DCN No. **E91031-00-D**

# DOCUMENT CHANGE NOTICE (DCN)

DOCUMENT No. (DOC-REV-GP. ID)	TITLE	NEW REV.
D980451-A	Cryo-Pump Cone Baffle	B

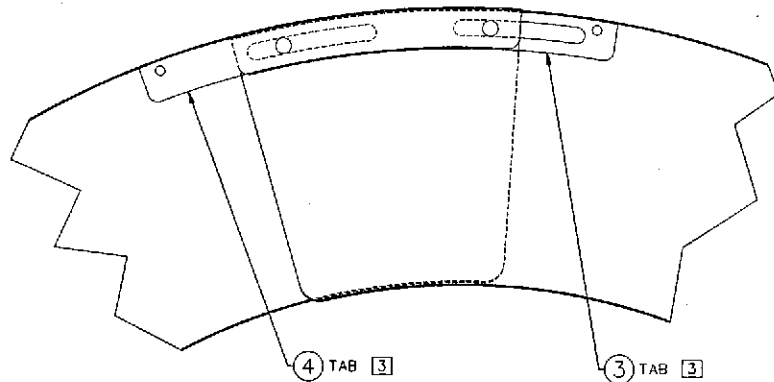
- i Lengthened slots on part item 4 (Tab).
- ii Changed overall length of part item 5 (Band) from 148.1 to 147.60 and removed removed drawing note 7 callout from dimension.
- iii Changed drawing notes 7 & 8.
- iv Added drawing note 8 callout on sheet 2.
- v Added drawing note 15.

- ⑤ NOTE THAT THESE RADI! ARE SLIGHTLY DIFFERENT ON EITHER TAB (ITEM 3 & ITEM 4).
- ⑥ ITEM 2 ONLY.
- ⑦ ALT: STANDARD 304L STAINLESS, POLISHED #8 FINISH, 20ga.

- ⑧ NOTED SIDE TO BE POLISHED SIDE.
- ⑨ STAMP OR ENGRAVE BASIC PART NUMBER AND SERIAL NUMBER IN THIS REGION AS FOLLOWS \*D980451 s/p-XXX\*, WHERE \*XXX\* IS A CONSECUTIVE INTEGER 001 ETC., LETTERING TO BE .12 HIGH MIN.

15. THIS IS A UHV APPLICATION AND ALL STOCK METAL SURFACES ARE TO BE CLEANED, NO MILL IDENT. MARKS, OR FORMING DISCOLORATION IS PERMISSIBLE ON PART.
